ECE/TRANS/WP.29/GRSG/2008/19
7 August 2008

REGULATION No. 107
(M₂ and M₃ vehicles)

Proposal for draft amendments to Regulation No. 107

Submitted by the expert from Spain */

FIGURE 1.1

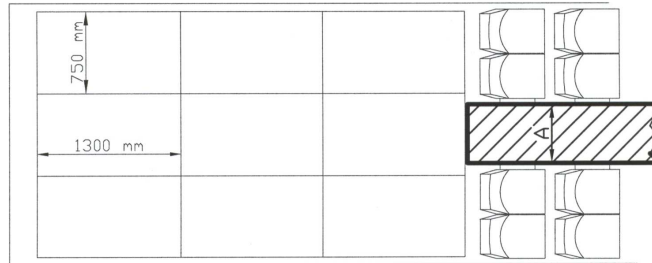
"2.15. "Gangway" means the space providing access by passengers from any seat or row of seats **or each special area for wheelchair users** to any other seat or row of seats **or each special area for wheelchair users** or to any access passage from or to any service door or intercommunication staircase and any area for standing passengers; it does not include: "

To guarantee the appropriate access of all passengers or crew members to each wheelchair user's specific area, in order to, for example, give special care or attention, help with the wheelchair anchorage system, etc. (see FIGURE 1.1 and FIGURE 1.2 attached).
